Response to Public Comments

City of Cincinnati BSB Corridor Concept I-W and Cincinnati USA Regional Chamber Footprint Minimization

TO: KYTC and ODOT
FROM: HNTB Corporation
DATE: November 2, 2022
RE: Brent Spence Bridge Corridor Project | ODOT PID 89068 | KYTC Project Item No. 6-17

EXHIBIT A:

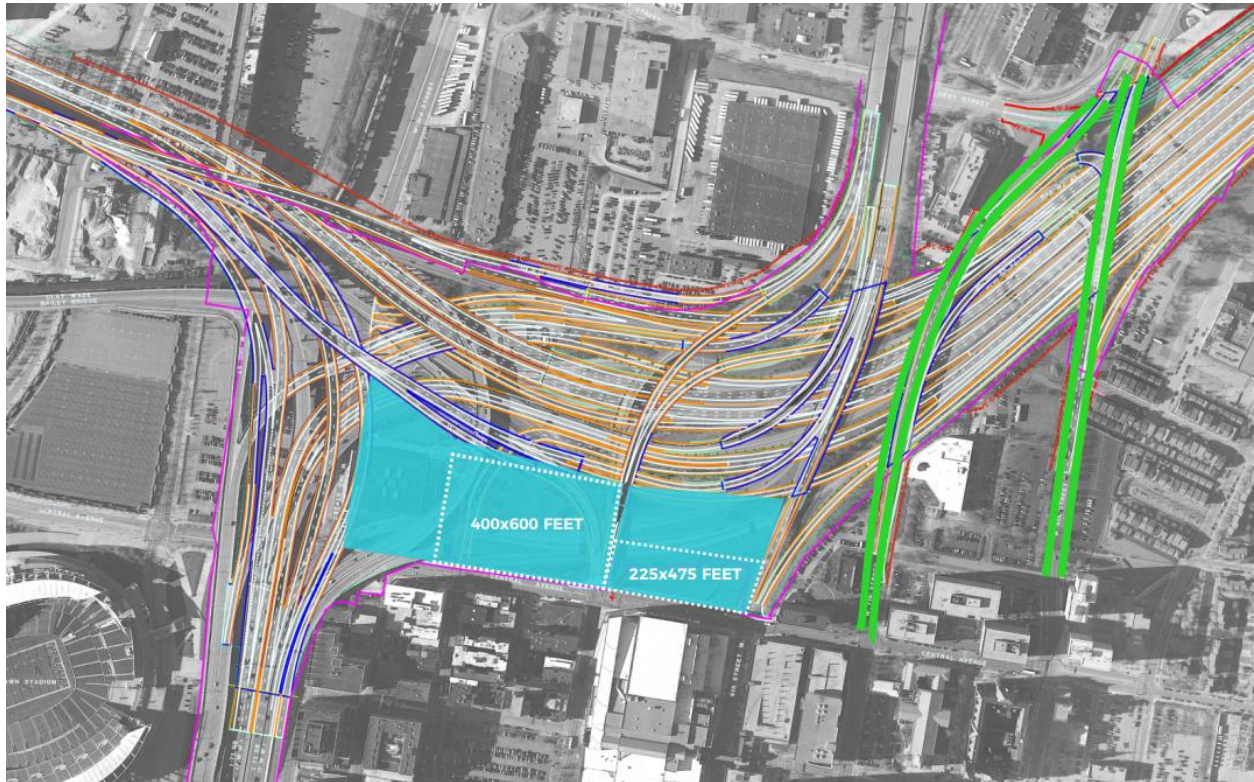
The City would like to evaluate options that would maximize the developable land between Central Avenue and the Interstate network. (Exhibit A) We would ask that ODOT evaluate the following options to help achieve that goal:

- Remove the ramps that access from 4th Street.
 - An additional ramp from 3rd Street to NB I-75.
- Minimize the footprint of the 5th Street ramps.
 - The NB ramp to 5th Street can create a T-intersection with the other ramps coming into 5th Street.
 - Shift the C-D road to the west since the 4th Street ramp is gone.
 - Potentially move to a two-way 6th Street.
- Direct connection from 6th Street to the mainline I75 northbound.
 - With the removal of the 4th Street ramp to the mainline a direct connection from 6th St should be created.
- Support future development
 - The City anticipates John Street being used to support future development in the space created in this area.
 - As design moves forward, ODOT and the City should make sure the interstate design doesn't preclude John St being used to support potential back of house uses for development.

After receipt of the City's comments, ODOT and HNTB met with City staff to discuss potential refinements to Concept I-W in the area between 3rd Street and 7th Street. Following the coordination meeting, HNTB evaluated the following ramp refinements in downtown Cincinnati (see Attachment 2):

- Removing the entrance from 4th Street to northbound I-75.
- Adding an entrance from 3rd Street to northbound I-75.
- Removing the southbound I-75 exit to 5th Street and reducing the number of lanes on the southbound collector-distributor (C-D) road from three to two.
- Reconfiguring the northbound I-75 exit to 5th Street to create a new signalized intersection with the US 50 ramp approximately 300 feet west of Central Avenue.
- Reducing the number of lanes on the eastbound approach to the 5th Street/Central Avenue intersection from four to three.
- Removing the connection between 6th Street and Winchell Avenue.
- Providing a connection between 6th Street and the northbound C-D road and northbound I-75.
- Widening the southbound I-75 ramp to 7th Street from one to two lanes.

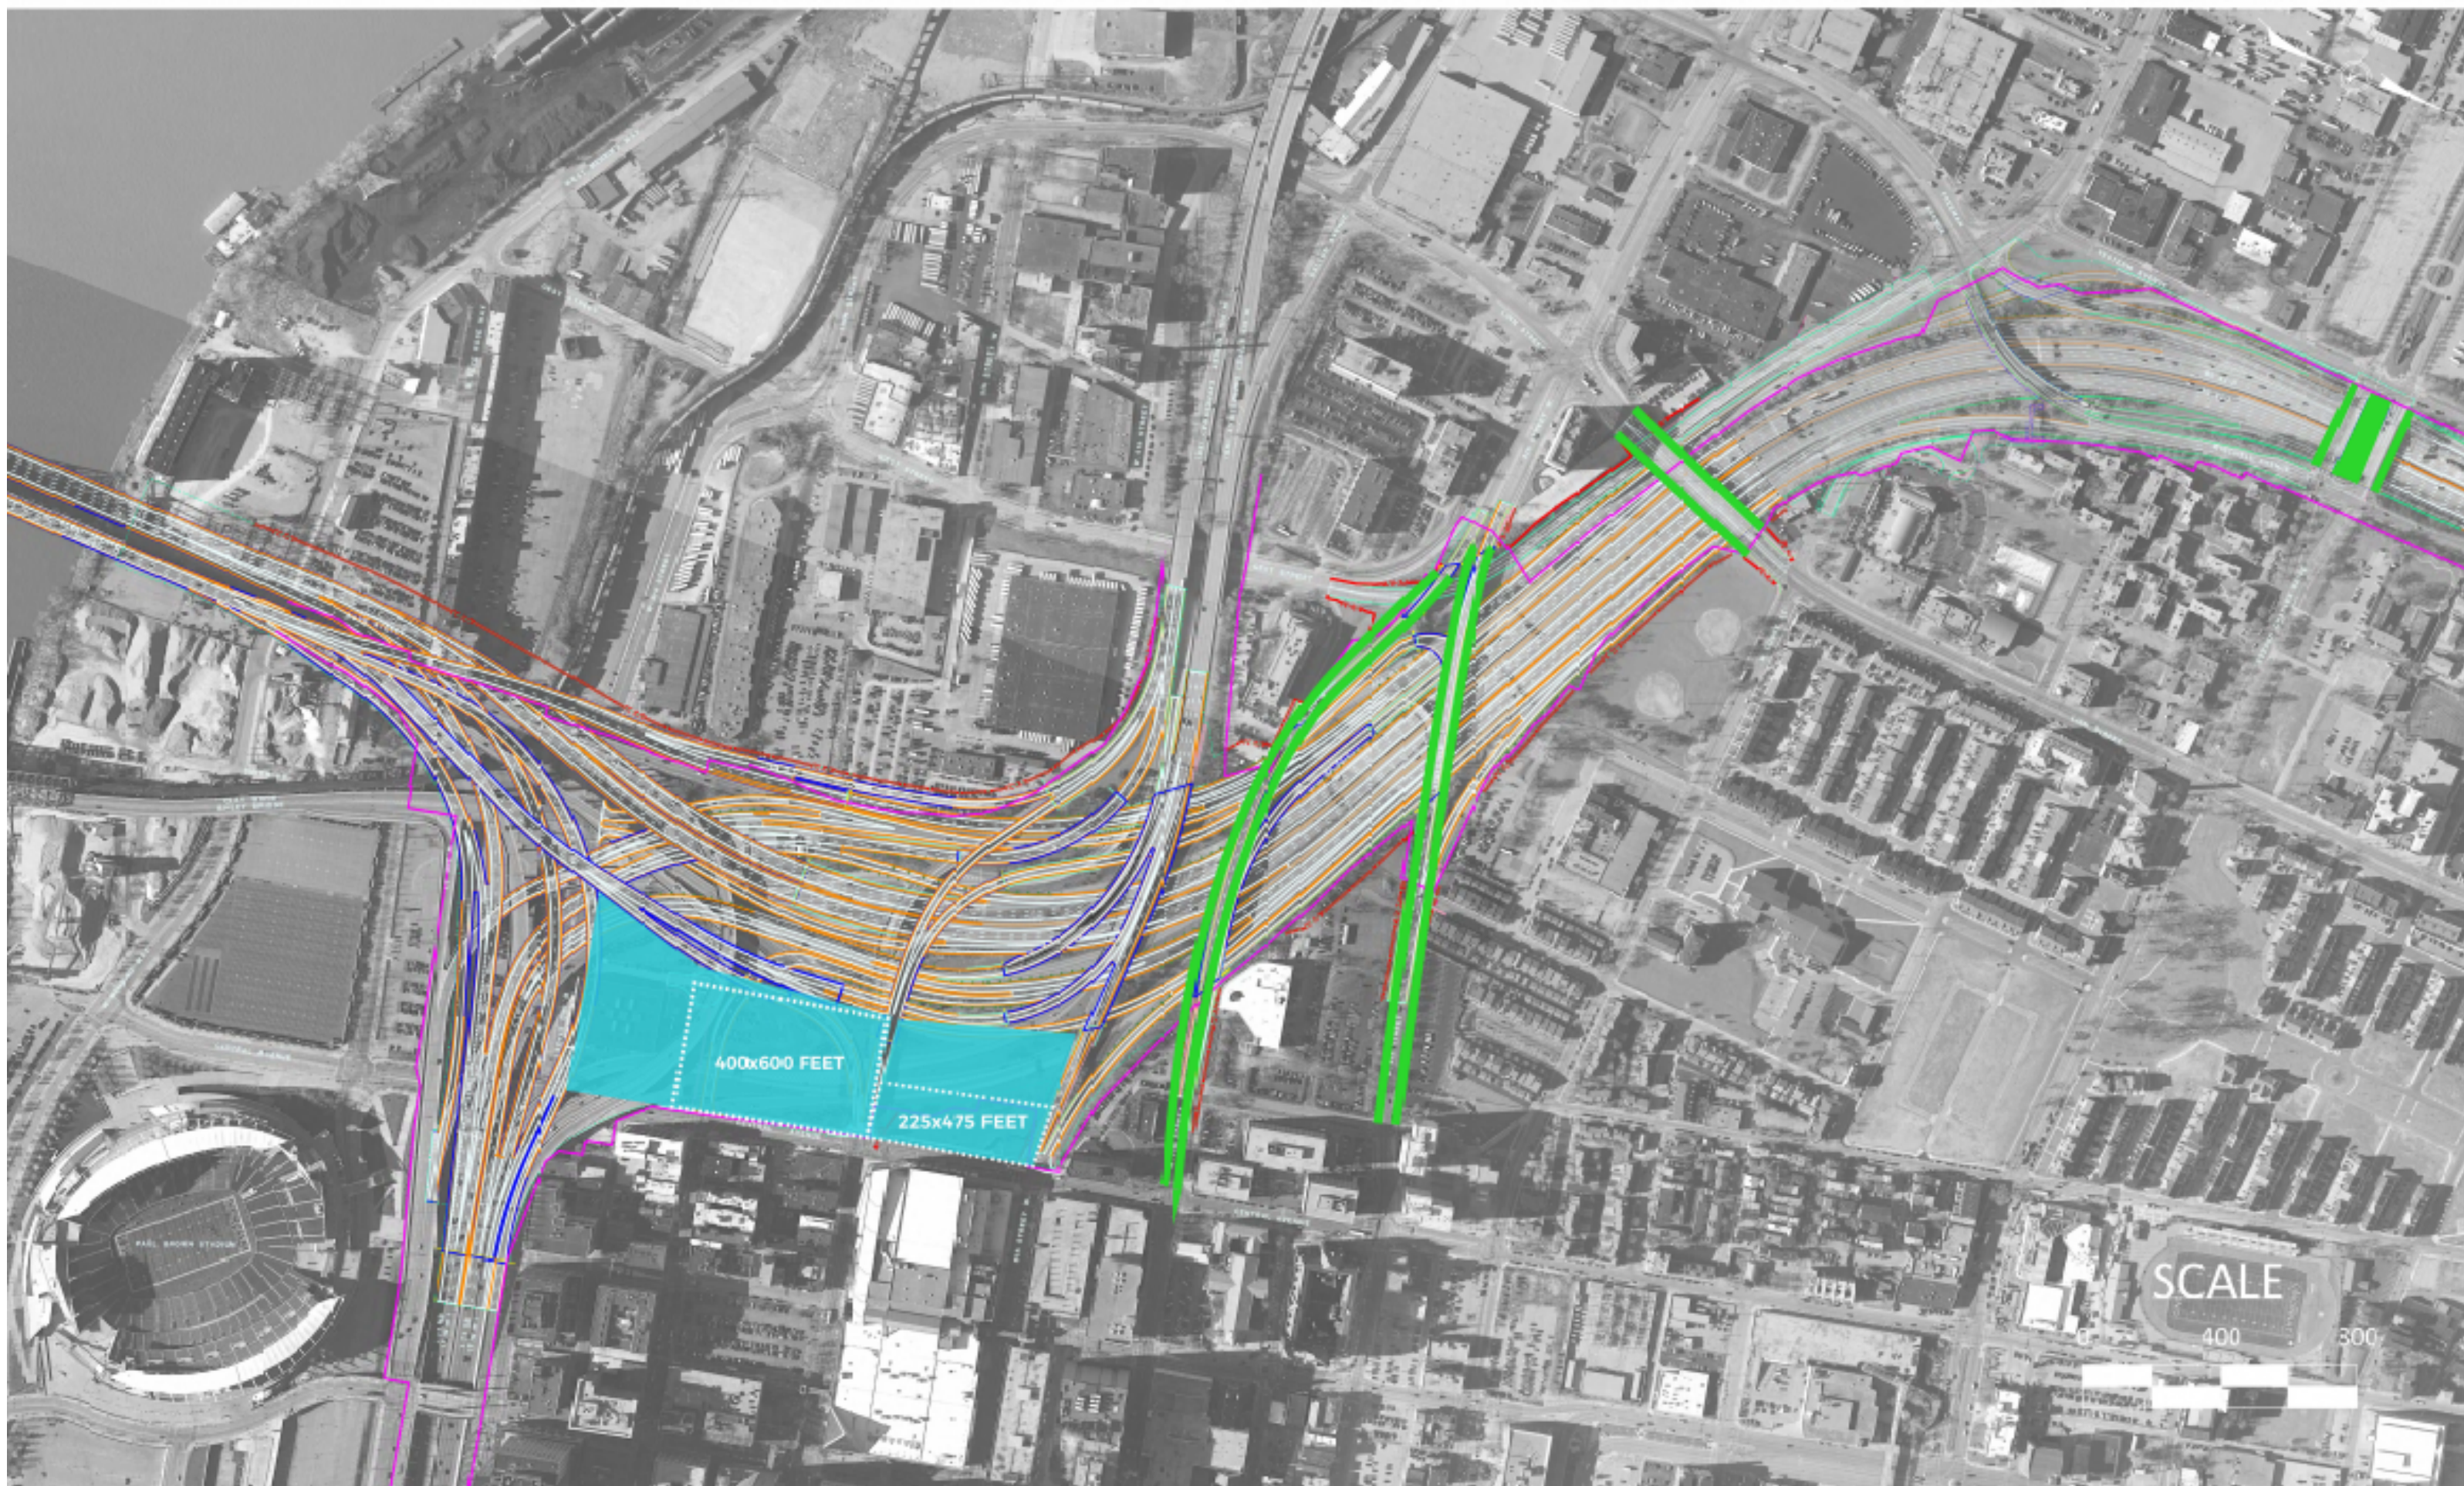
Attached please find the map that was developed over the last month+ with stakeholders we convened to identify and quantify the valuable minimum thresholds for developable land should it be possible to retain it in the design build phase of BSB. A few things worth noting:

1. The Blue sections are the desired areas, while the dotted lines delineate the minimum thresholds for Convention Center opportunities to the west.
2. The green lines indicate the areas where I understand the City and ODOT are discussing Long Street style treatment on connection points across the footprint. Throughout the room there was excitement for this concept and support for it. We included it here to make sure you understood that we were aligned in talking about both.

Attachment 2: Proposed Ramp Refinements

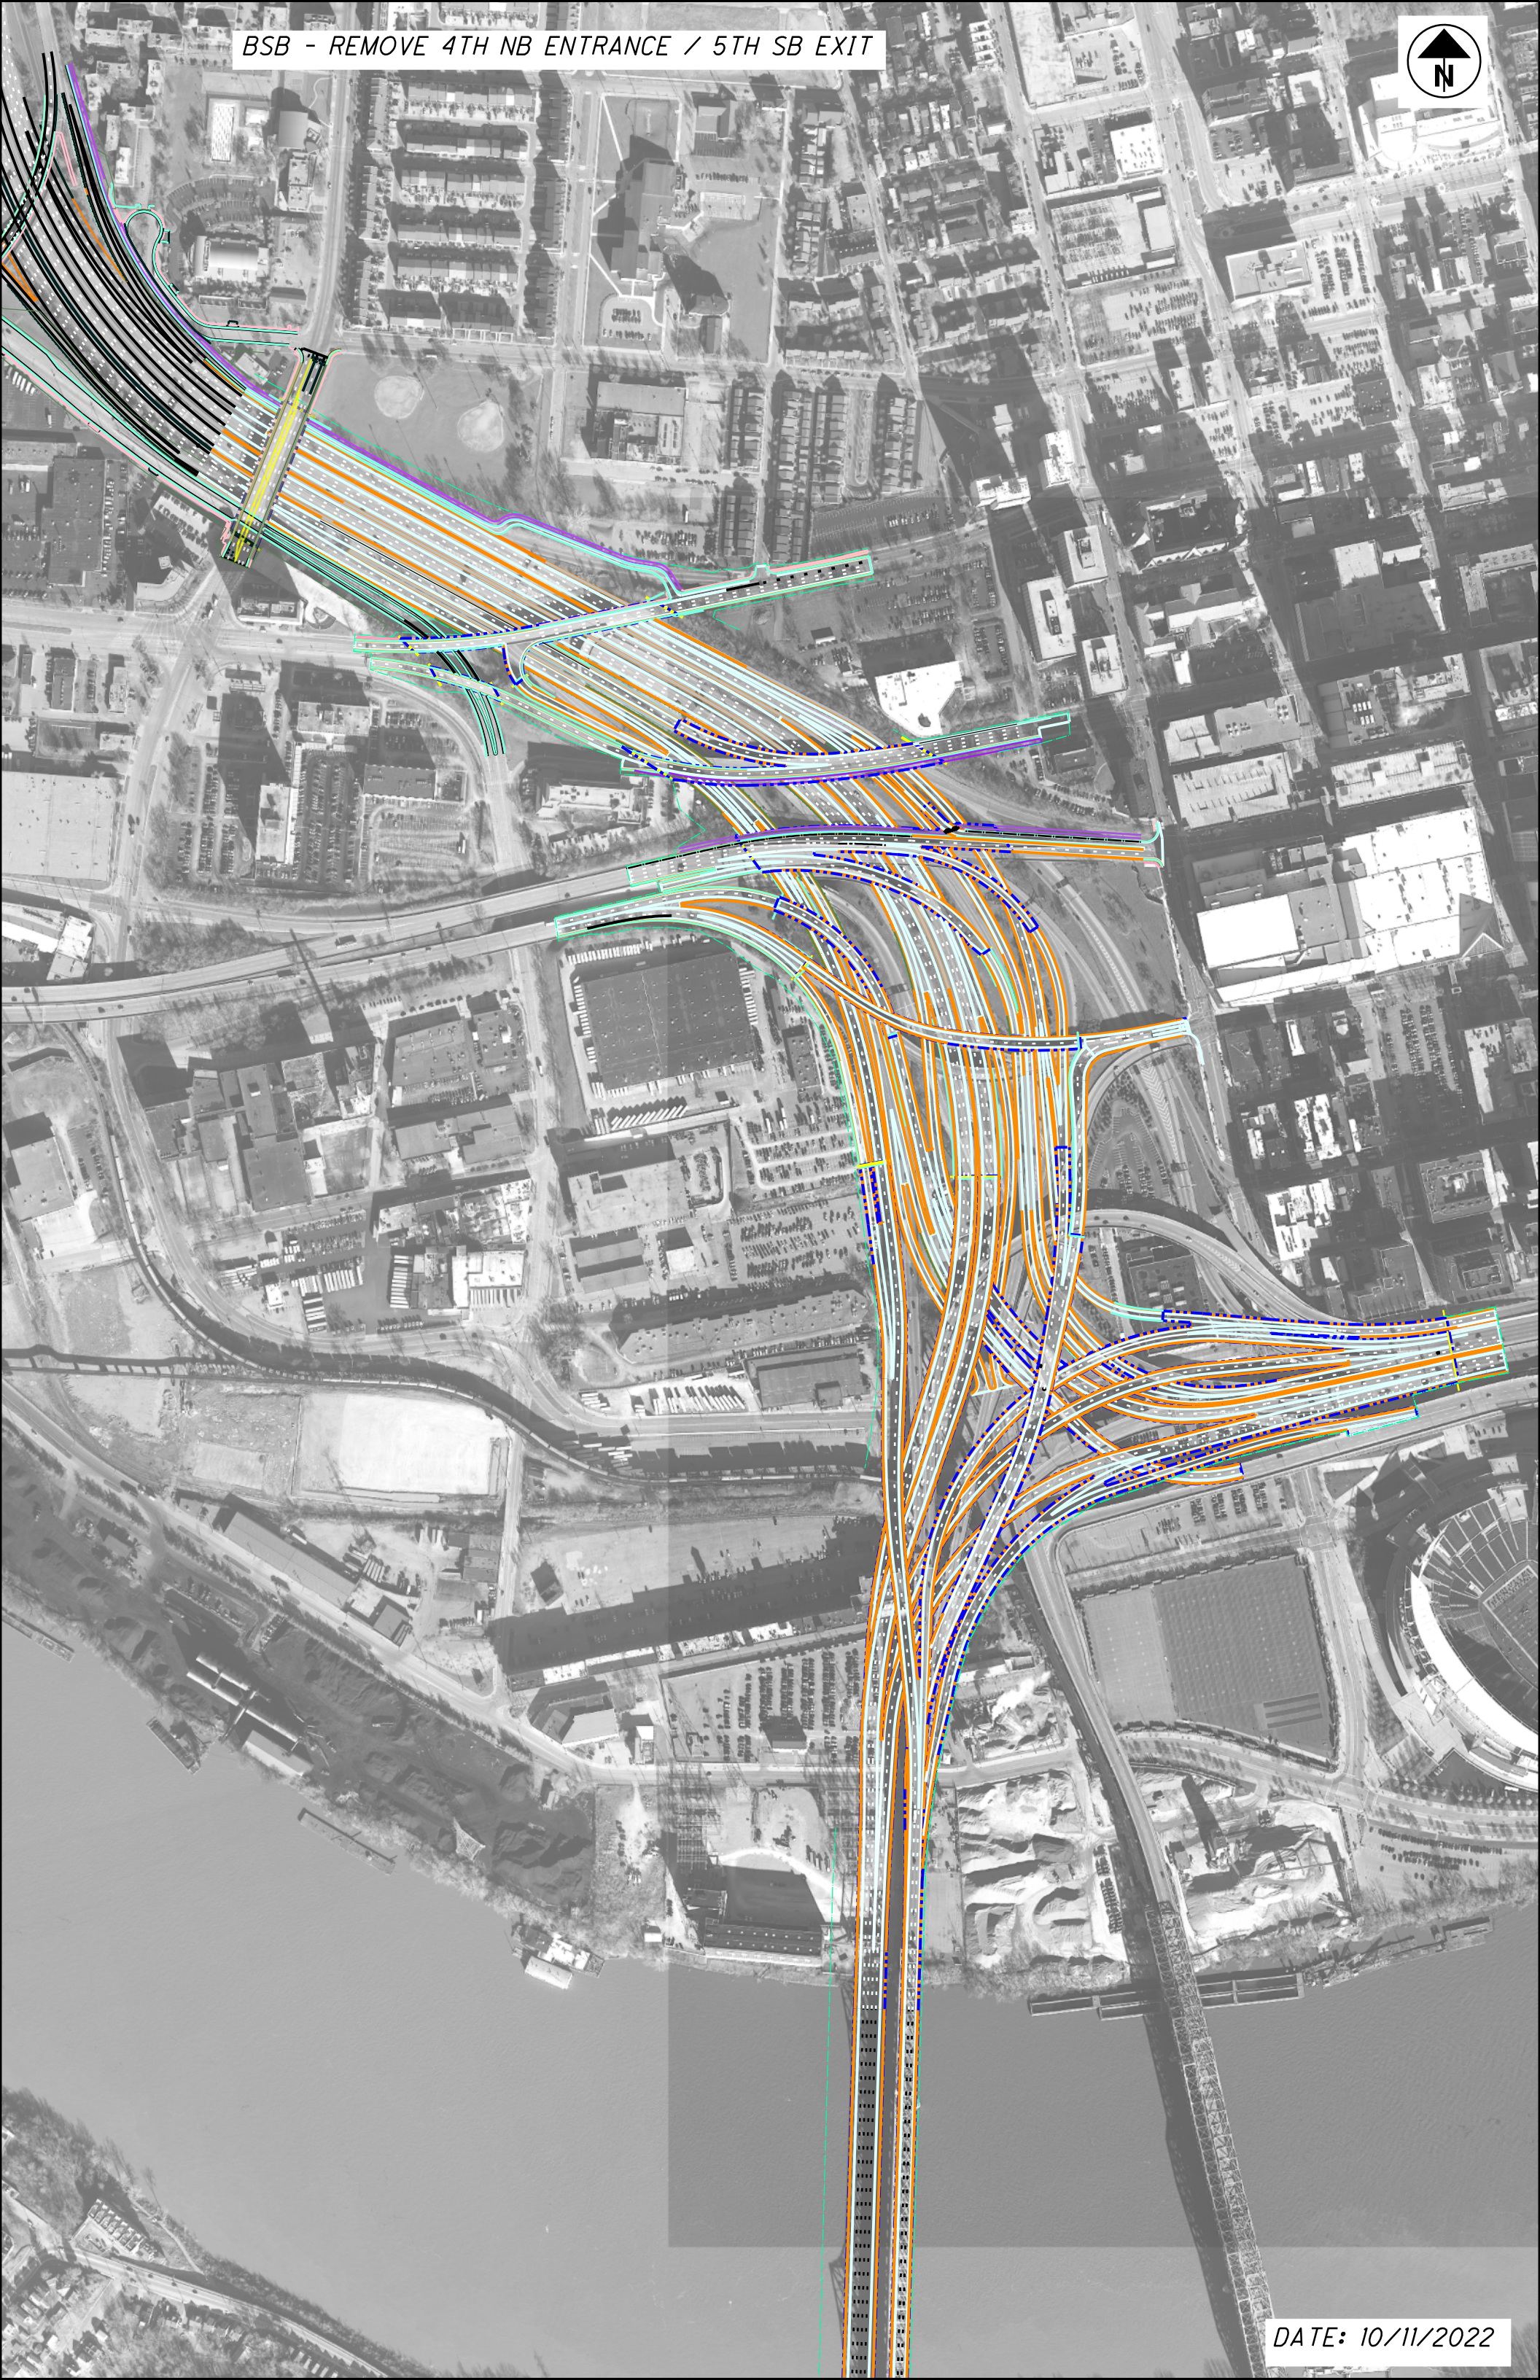
BSB - REMOVE 4TH NB ENTRANCE / 5TH SB EXIT

Figure 1: Concept I-W Design Refinements

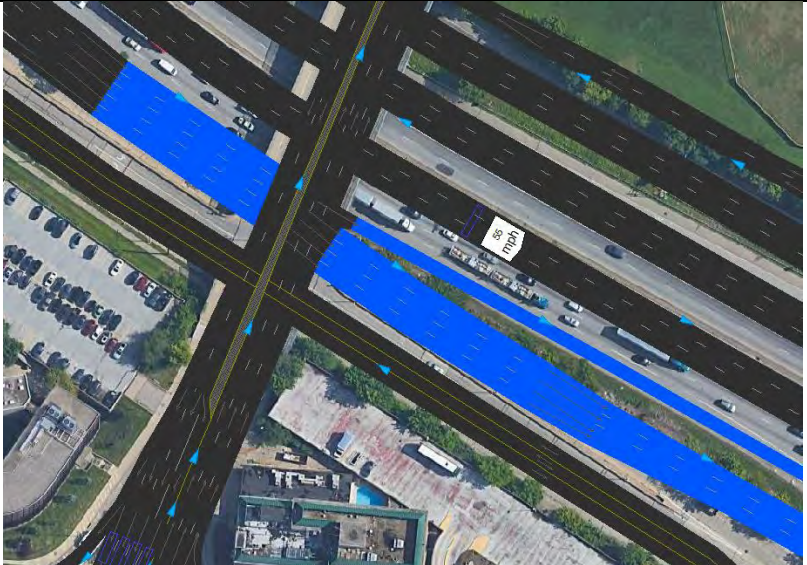
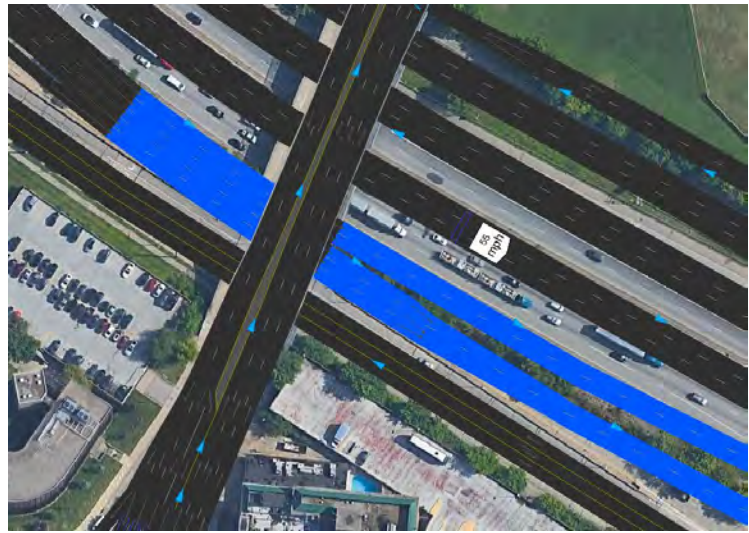
- Removal of SB I-75 Exit to 5th Street
- Removal of the NB I-75 entrance from 4th Street
- Addition of NB I-75 entrance ramp from 3rd Street
- Modification of 6th Street ramp geometry
- New signalized intersection between the NB I-75 exit ramp and US 50
- Reduced lanes for EB approach at 5th Street & Central Avenue Intersection

Due to traffic impacts from the 5th Street ramp removal, additional improvements are recommended for SB I-75 CD and SB I-75 exit ramp to 7th Street. With these proposed changes the traffic operations are acceptable in the project study area captured in the TransModeler network. The IMS forecasts and operations analysis will include additional intersections east of Central Avenue, which will provide a final analysis to understand the traffic impacts of the 4th Street ramp removal. The proposed geometric refinements for Concept I-W are shown in the figure below.
